CNP UNITS 1 AND 2 IMPROVED TECHNICAL SPECIFICATIONS CONVERSION

ITS CHAPTER 1.0 USE AND APPLICATION

ITS Chapter 1.0, Use and Application

**Current Technical Specification (CTS) Markup
and Discussion of Changes (DOCs)**

OPERATIONAL MODE

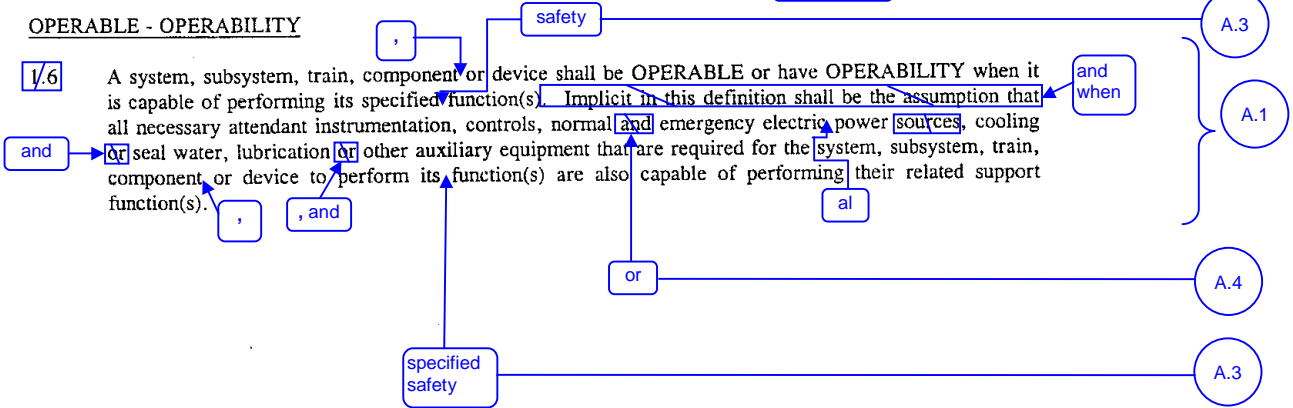
1.4 An OPERATIONAL MODE shall correspond to any one inclusive combination of core reactivity condition, power level and average reactor coolant temperature specified in Table 1.1 with fuel in the reactor vessel (moved from Table 1.1)

INSERT 1

, and reactor vessel head closure bolt tensioning

- A.2 CTS Section 1.0 and Table 1.1, "OPERATIONAL MODES," provide a description of the MODES. ITS Section 1.1 and Table 1.1-1, "MODES," changes the CTS MODE definitions in several ways:

This change is acceptable because the revised phrase is consistent with the current interpretation and usage. MODE 6 is currently declared when the first vessel head closure bolt is detensioned. This change also eliminates a redundant phrase. The reactor vessel head cannot be removed unless the reactor vessel head closure bolts are unbolted. Since "reactor vessel head unbolted" is already specified in the CTS Note, including "or removed" is unnecessary.
